E8362C-01

S E R V I C E N O T E

E8362C PNA Microwave Network Analyzers

A new touchscreen display inverter shield is available to improve PNA noise floor performance.

Figure 3

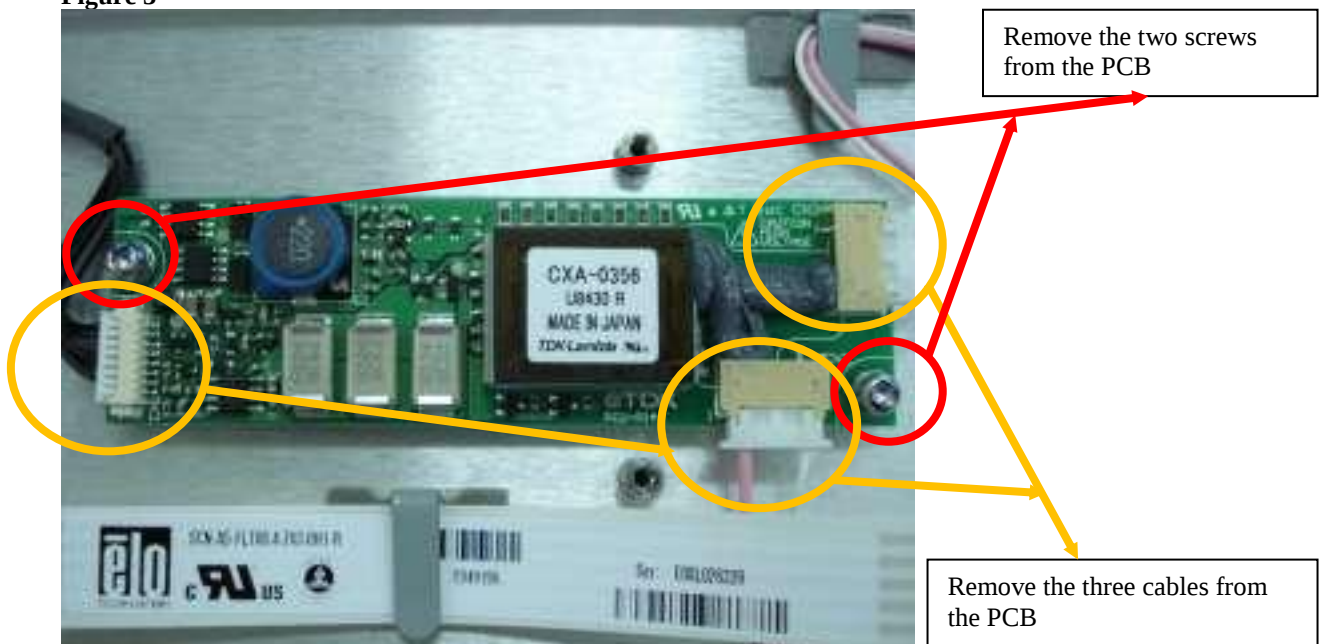
10. Remove the two screws from the PCB shown in Figure 3, using a T-10 wrench.
Disconnect the three cables connected to the PCB.
